# Recall Bulletin

## PRODUCT SAFETY RECALL

**SUBJECT:** TRANSMISSION MOUNT BROKEN

**MODELS:** 2013 Chevrolet SPARK

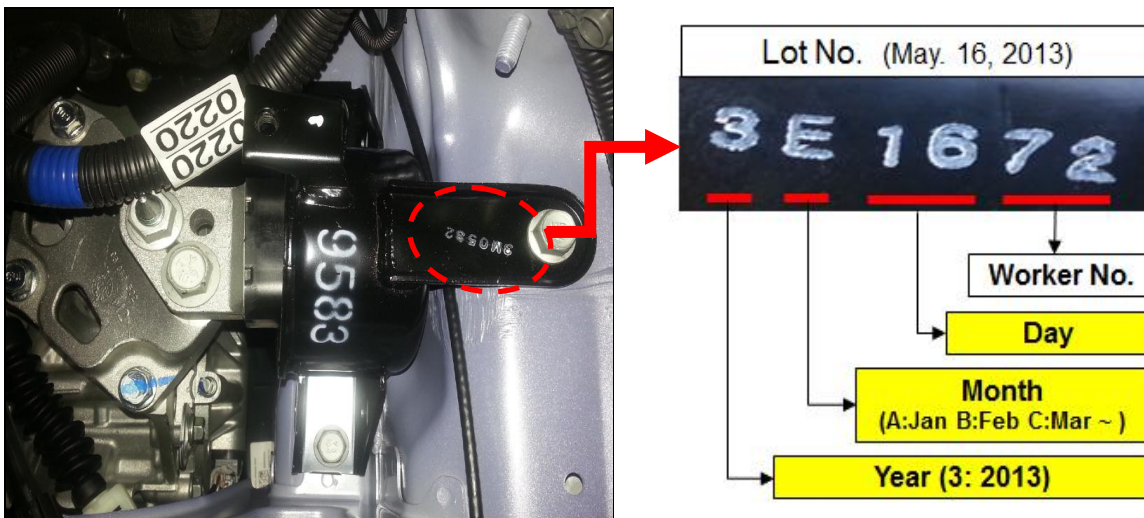
1. Remove the battery tray. (Refer to service manual).
2. Check the Lot No. at upper area of transmission mount as below picture.

➤ [Replacing Lot No. : 3E09~3F07 \(2013.5.9 ~ 2013.6.7\)](#)

1. If it is not in the replacement range(Lot No.: 3E09~3F07), install the battery tray.

2. If it is in the replacement range(Lot No.: 3E09~3F07), replace the transmission mount with new one. (Refer to service manual)
